CHAPTER 5 DRAFT SEIR-2 ERRATA

5.1 DRAFT SEIR-2 TEXT AND FIGURE ERRATA

This Chapter contains text and figure changes to the Draft 2nd Supplemental Environmental Impact Report (SEIR-2) as a result of comments received on the document and updated information. Text changes related to the nine design refinements are shown in **Chapter 2, Design Refinements**, of this Final SEIR-2. Text that has been deleted from the Draft SEIR-2 is shown with a ~~strikeout~~ through the deleted text. Text that has been added is shown with **bold-underline**. The locations of the revisions are indicated by the headings, subheadings, paragraph numbers, page numbers, or other reference to assist the reader in locating the changes to the Draft SEIR-2. Where a revision is in response to a comment, it has been noted. The revised Draft SEIR-2 figures are included at the end of this Chapter.

Revised Figure 4.13-3A: Noise and Vibration Mitigation Locations

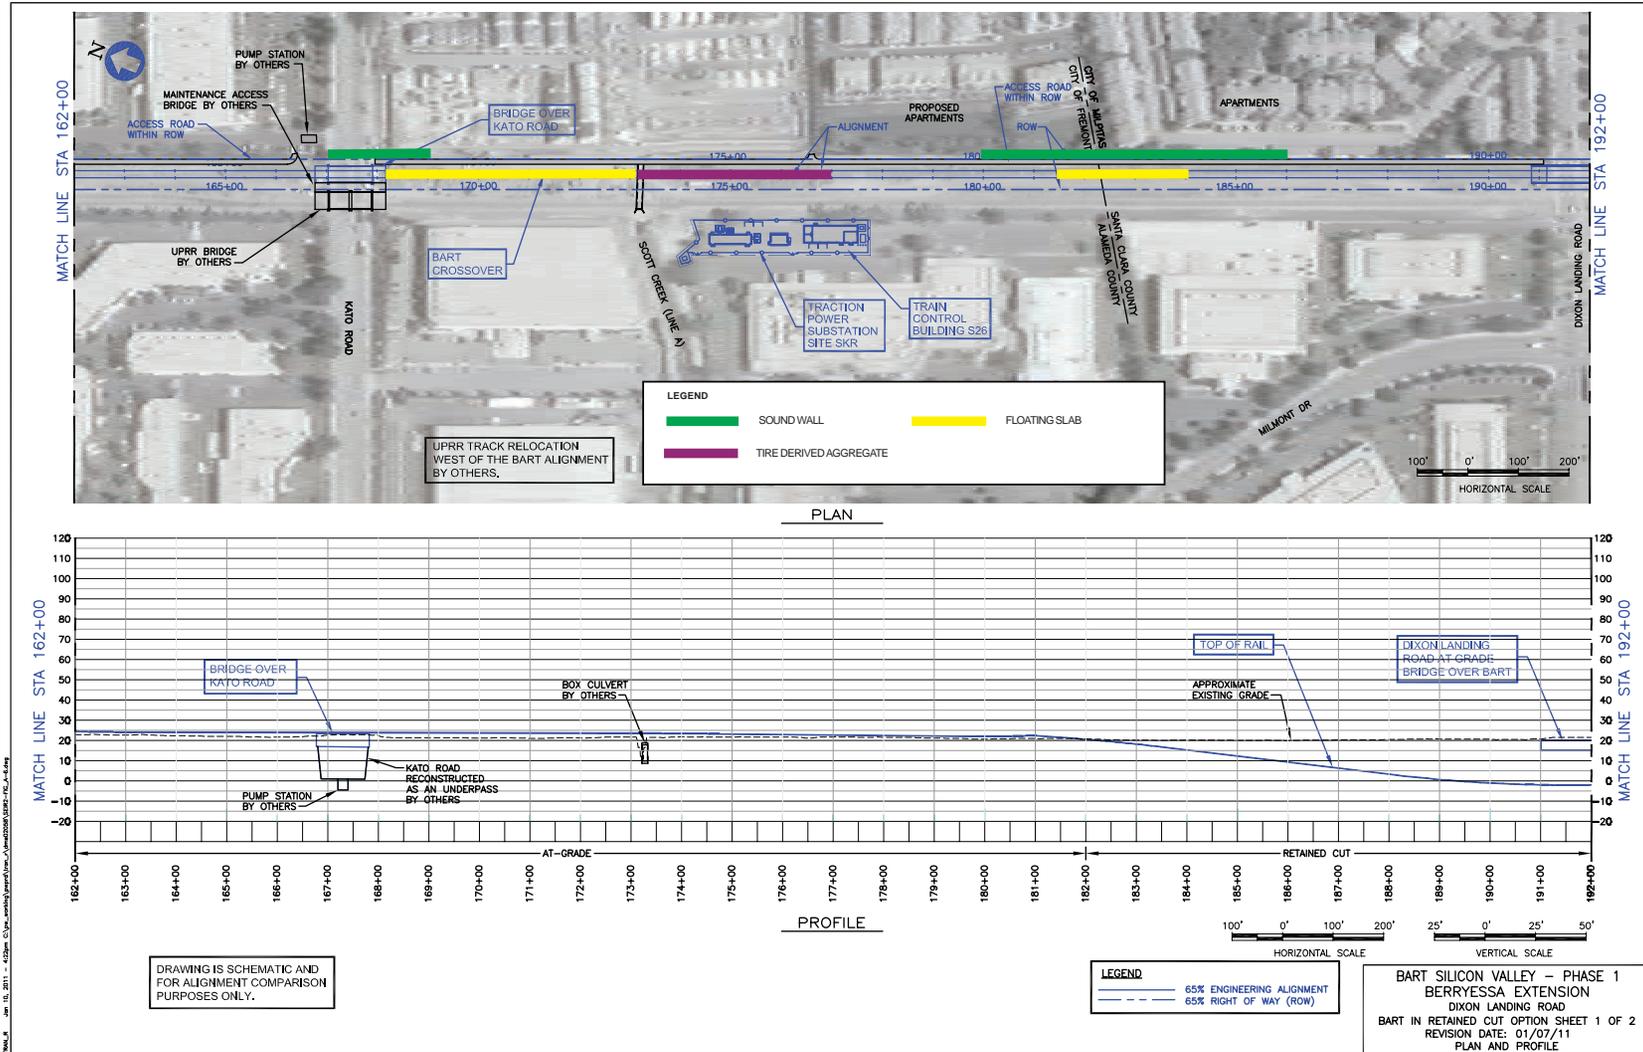
Figures 4.13-A through 4.13-3J of the Draft SEIR-2 have been revised to show the updated noise mitigation locations. New Figures 4.13-3H(a) and 4.13-3I(a) have been added to the Draft SEIR-2 to show the middle sound barrier noise mitigation option in lieu of the track level sound absorption panels. A new Figure 4.13-3K has also been added to the Draft SEIR-2 to show the noise mitigation location at the Berryessa Station. These revised and new figures are shown at the end of this Chapter.

Revised Figure 4.13-3H: Noise and Vibration Mitigation Locations

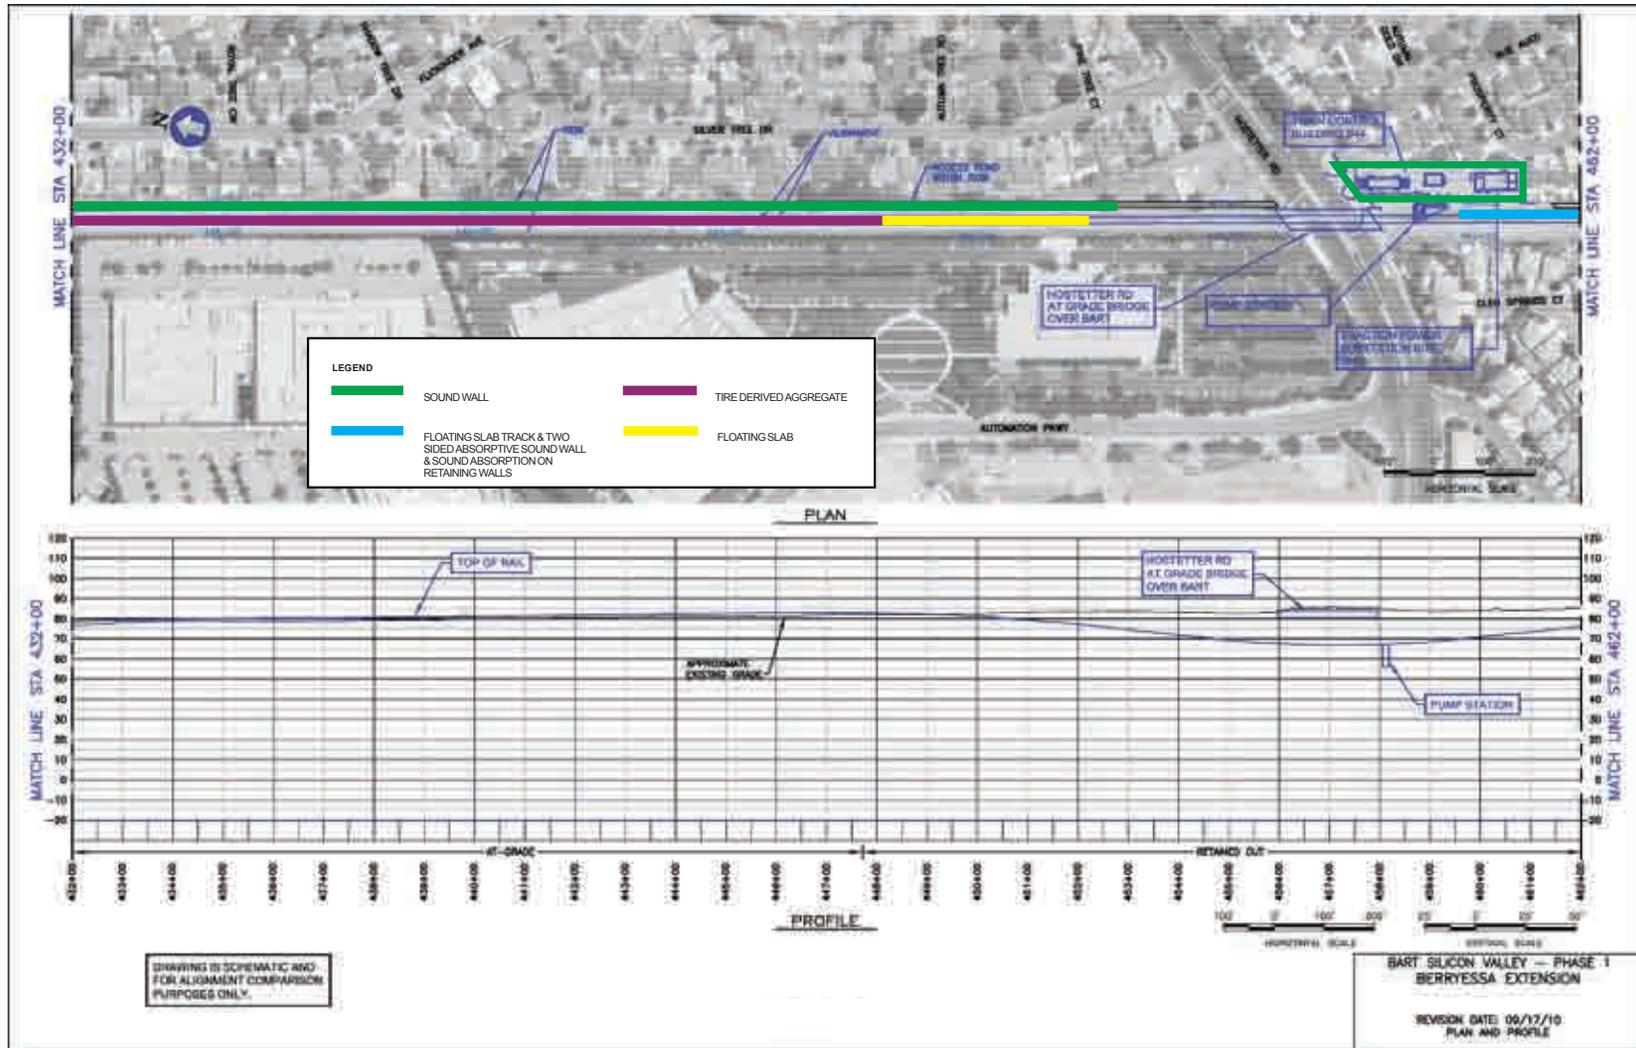
<p>4.13-3KJ in the SEIR-2. <u>Figures 4.13-3H and 4.13-3I show the location of the track level sound absorption panel noise mitigation option and Figures 4.13-3H(a) and 4.13-3I(a) shows the location of the middle sound barrier noise mitigation option.</u></p>	
<p>Phase 1 Alignment Noise Impacts: Between Hostetter Road and Sierra Road. The Berryessa Station would include an 8-foot high community wall near the residential areas to the east, which would reduce noise impacts. The community wall would need to be extended northward to reduce noise impacts for residences on Salamei Court and Mabury Road. The need for additional noise insulation of at the nearby residences would be determined on an individual basis.</p> <p>In the area of the alignment between Hostetter Road and Sierra Road, it was determined that a sound wall would not be a practical noise mitigation measure because receptors in this area have an existing sound wall at their backyard property line. It is estimated that the receptor's sound walls would provide shielding of wayside project noise of 15 dB, which is the maximum reduction of a sound wall recognized by the FTA for a single noise barrier. As shown in Table 4.13-4, receptors in this area are projected to encounter a noise level increase of <i>Moderate Impact</i>. This is primarily due to the 3 dBA increase in noise levels associated with the FST. Implementation of track-level acoustical absorption would eliminate the increased noise levels.</p>	<p>S</p>	<p>Mitigation Measure NV-2: Approximately 2,500 2,000 feet of slab track acoustical absorption at track level shall be used to reduce adverse noise effects in the area of the alignment between Hostetter Road and Sierra Road. This mitigation shall occur between civil station STA 459+50 and 486+50 as indicated in Table 4.13-6.</p> <p><u>Alternatively, a middle sound barrier could be installed between STA 459+50 and 486+50 and designed to achieve a similar reduction in noise levels. A two-sided, absorptive sound barrier in the middle of S1 and S2 tracks with a minimum height of five feet above the top of rail is an alternative to track level absorptive panels. In addition to the middle sound barrier, sound absorptive material would be required on both retaining walls of the retained cut. The sound absorptive material on the retaining walls would be placed as low as possible and cover a minimum of four feet in vertical extent. The material should possess a minimum noise reduction coefficient of 0.65 and a minimum absorption coefficient of 0.60 at 500 Hz. Should an alternative noise mitigation measure be evaluated and selected, that mitigation measure would be required to provide a comparable noise reduction. Figures 4.13-3H and 4.13-3H(a) and 4.13-3I and 4.13-3I(a) show the location of the noise mitigation options between Hostetter Road and Sierra Road.</u></p> <p>Mitigation Measure NV-3: During the project start-up phase and prior to revenue operations, VTA will carry out noise testing along the civil stations where slab track acoustical absorption is being used as a mitigation measure. The testing is to ensure that the sound absorber is adequately attenuating the increased noise from the slab track. VTA will deliver a technical memo to the FTA on the results of the testing. The testing will also serve to inform the need for additional wayside residential noise mitigation mentioned in Mitigation Measures NV-1 and NV-4.</p> <p>Residences located on or at the second floor or higher would continue to experience noise levels that exceed the FTA criteria, even with the recommended sound wall mitigation, which is considered to be at the maximum feasible height. Approximately 425 residences (including single family and individual units in multi-family residences) in 281 buildings would remain exposed to noise in excess of the FTA criteria for a <i>Severe Impact</i>. Where needed, these residences would be considered for improved building insulation as</p>	<p>LTS</p>

Figures 4.13-3H and 4.13-3H(a) and 4.13-3I and 4.13-3I(a) show the location of the noise mitigation options between Hostetter Road and Sierra Road.

Alternatively, a middle sound barrier could be installed between STA 459+50 and 486+50 and designed to achieve a similar reduction in noise levels. A two-sided, absorptive sound barrier in the middle of S1 and S2 tracks with a minimum height of five feet above the top of rail is an alternative to track level absorptive panels. In addition to the middle sound barrier, sound absorptive material would be required on both retaining walls of the retained cut. The sound absorptive material on the retaining walls would be placed as low as possible and cover a minimum of four feet in vertical extent. The material should possess a minimum noise reduction coefficient of 0.65 and a minimum absorption coefficient of 0.60 at 500 Hz. Should an alternative noise mitigation measure be evaluated and selected, that mitigation measure would be required to provide a comparable noise reduction.

Revised Figure 4.13-3K: Noise and Vibration Mitigation Locations

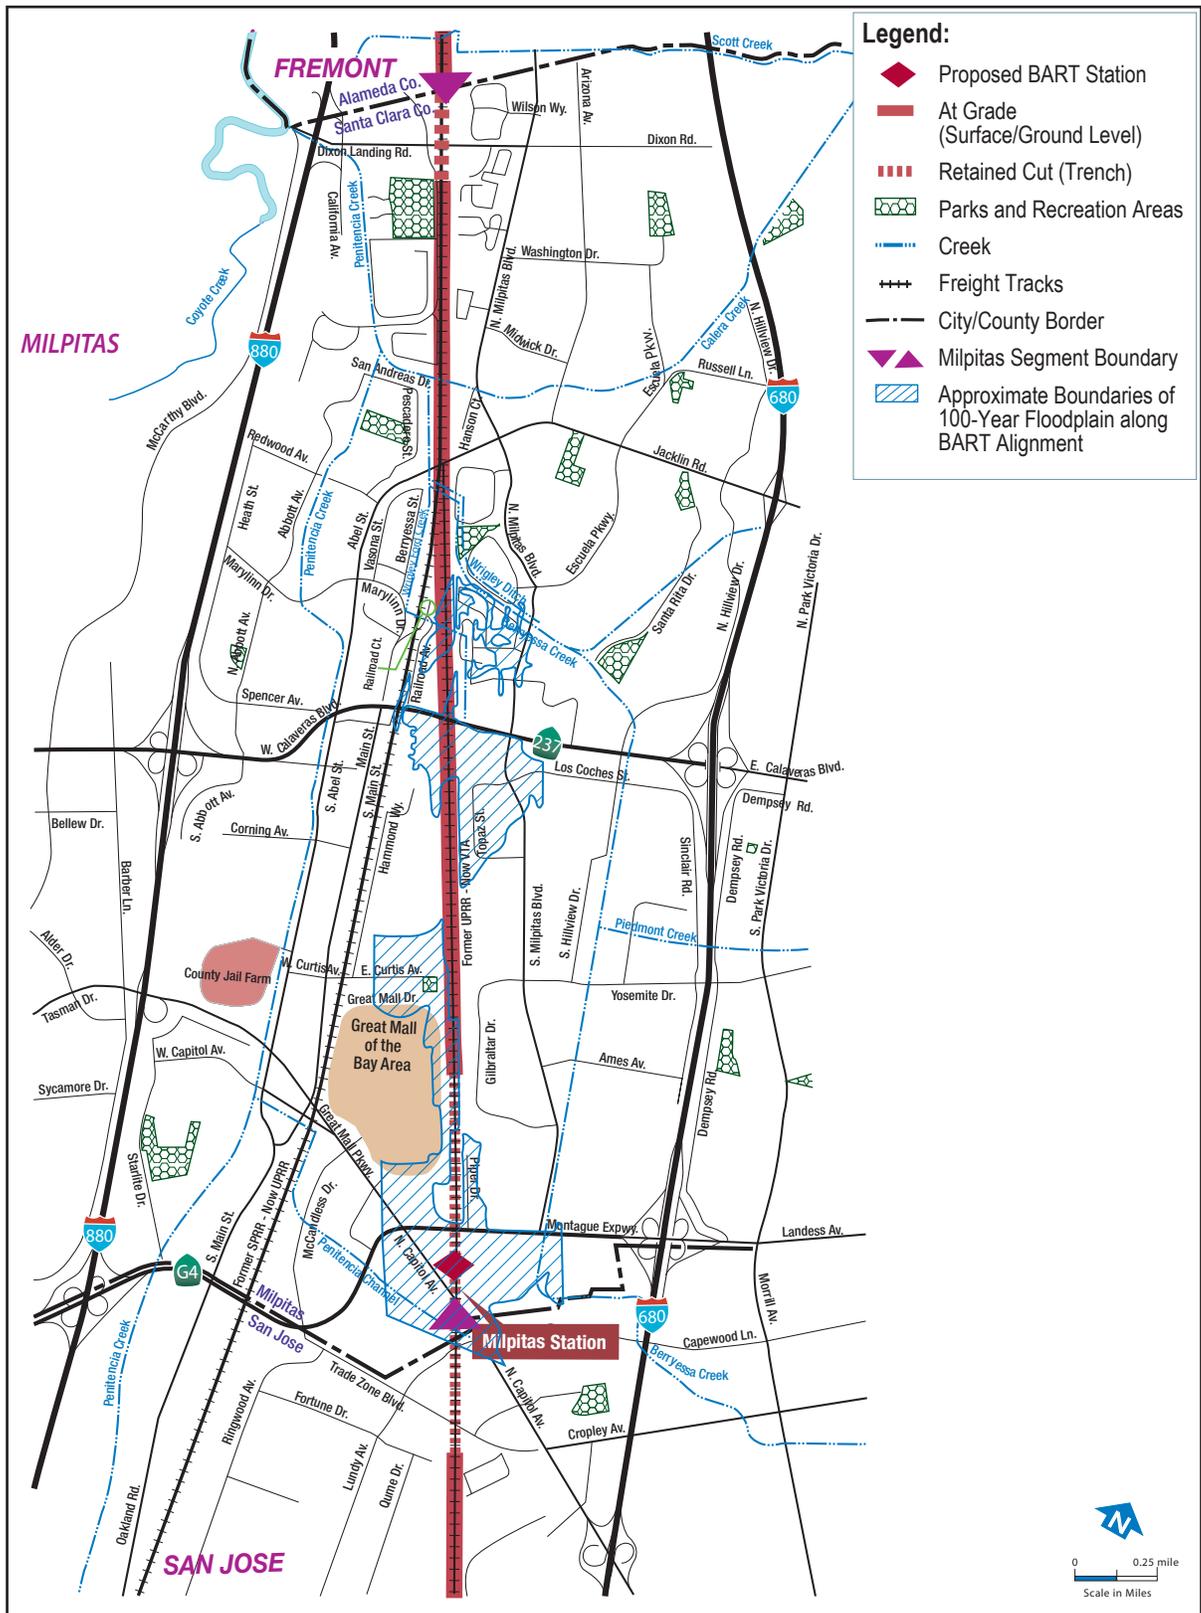
Mitigation Measure NV-5: **Table 4.13-9** summarizes the vibration mitigation necessary to achieve the FTA criteria. The proposed mitigation is tire derived aggregate and 8-Hz FST. The locations of vibration mitigation are depicted on **Figures 4.13-3A** through **4.13-3KJ**.

Revised Figure 4.18-2: 100-Year Floodplain Within the Phase 1 Area - City of Milpitas

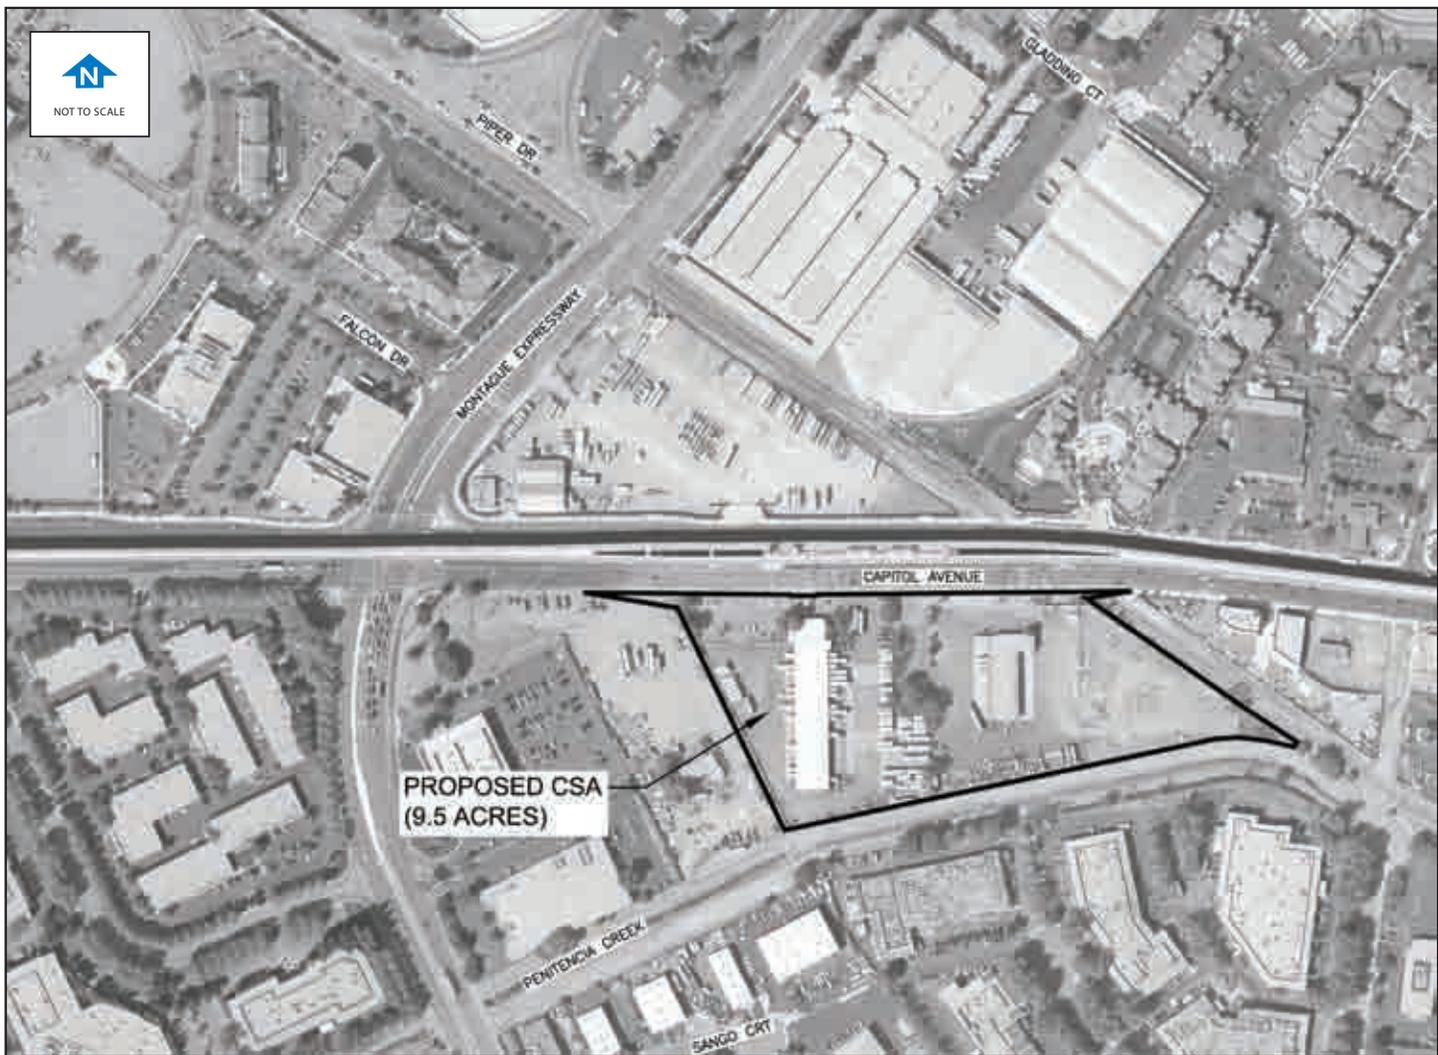
In response to comment L-2.3, **Figure 4.18-2** has been added to the Draft SEIR-2 to show the floodplains in the vicinity of Phase 1 in the City of Milpitas. The revised figure is shown at the end of this Chapter.

Revised Figure 4.19-6: Capitol Avenue Construction Staging Area

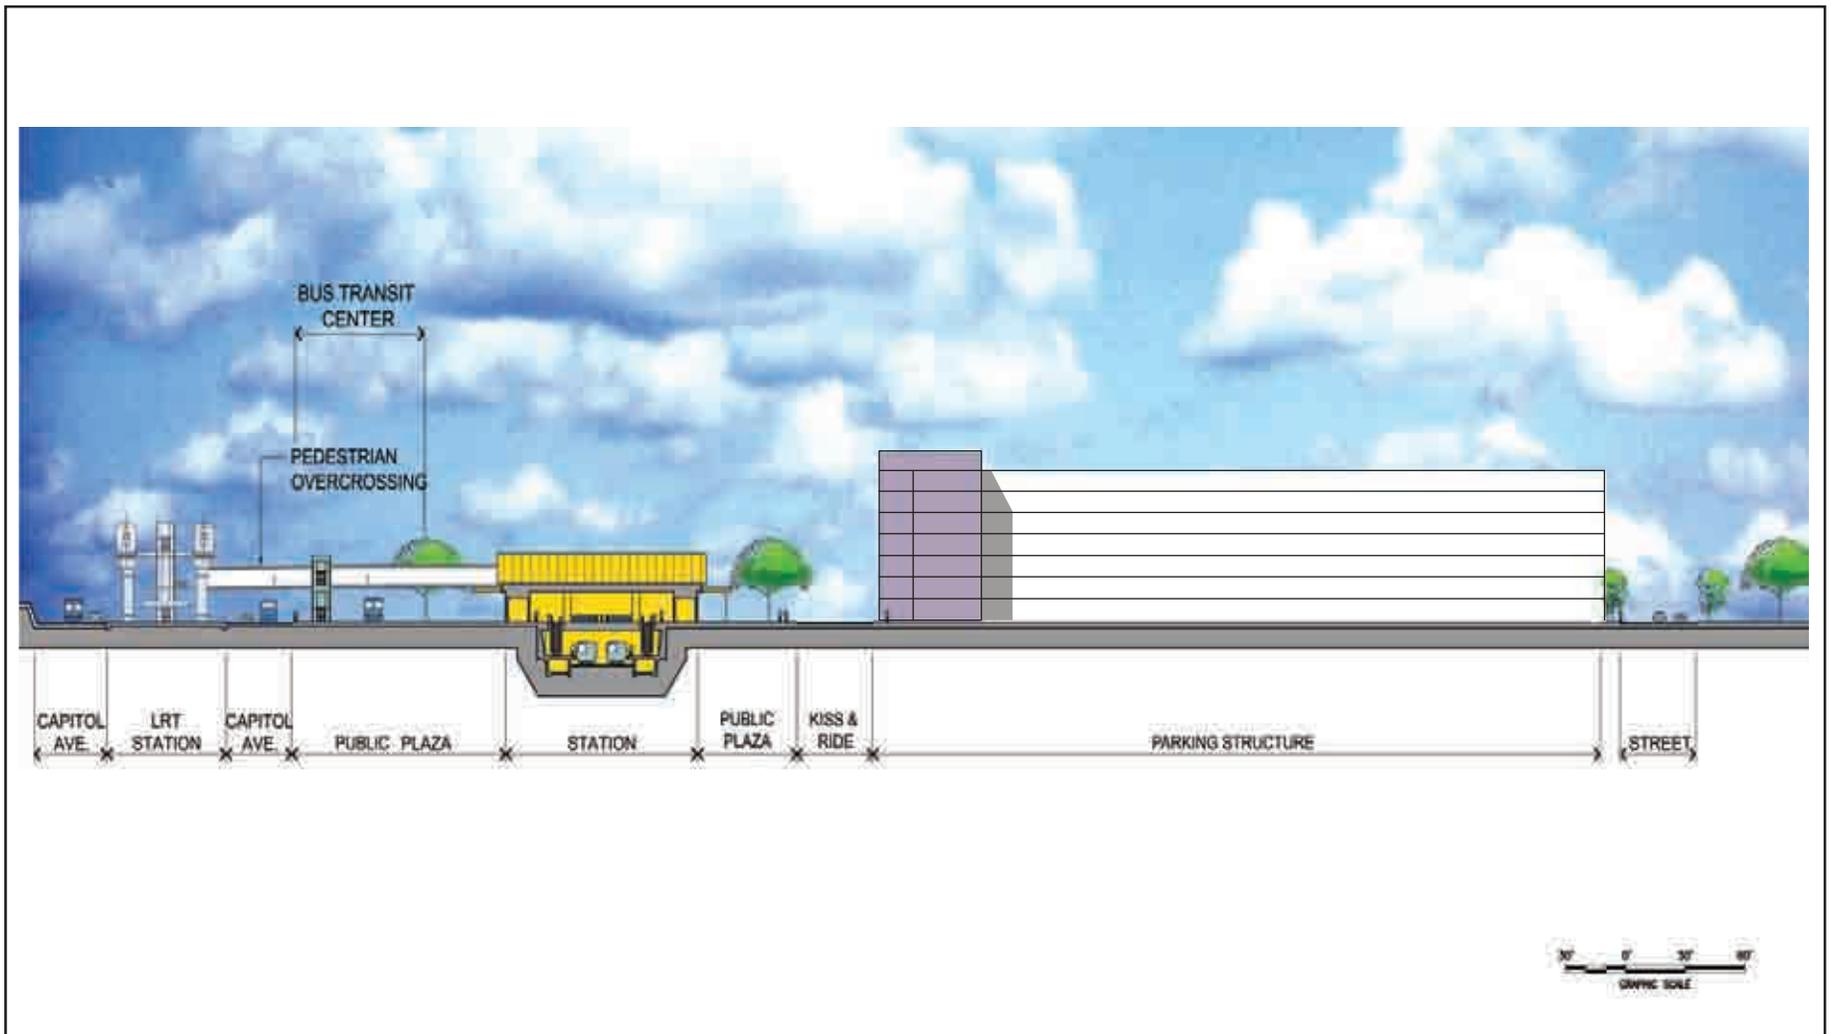
A figure showing the Capitol Expressway CSA has also been added; this figure was incorrectly omitted from the Draft SEIR-2.⁵ This new figure is shown as revised **Figure 4.19-6** at the end of this Chapter. The ordering of **Figures 4.19-2** through **4.19-9** has also been revised to correct an error in the Draft SEIR-2. The revised figure numbering sequence is as follows:
